RE: Douglas 234 Multitenant, Site Plan Review Comments 03
SITE ADDRESS: Lot 10B, Douglas 234 Filing No. 6, Amendment 2
County of Douglas, State of Colorado

Listed below are Electrical design review comments issued by Elizabeth Steward on May 5, 2026. Please refer to the corresponding comment responses and revised drawings attached for further information.

DIMENSIONS

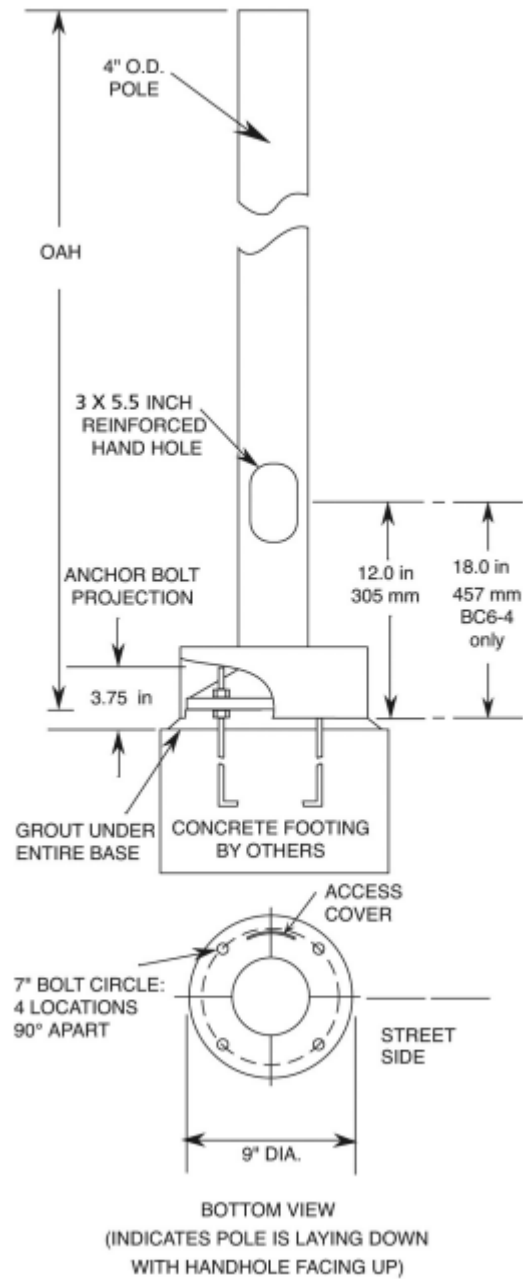
- **Response: Photometric has been updated/modified such that parking lots and drive aisles have a uniformity ratio of less than 6:1.**
5. Sheet LT2: Images of all proposed lighting implements and poles needed. Should show exactly what is being installed on the property as used for final inspection. Also ensure each shows the color and height of the poles/lighting implement.

- **Response: All proposed lighting implements are shown on the cut sheets. The exact specification of the poles (for Types P1 and P2) is not currently known. Please see image below of proposed pole dimensions.**
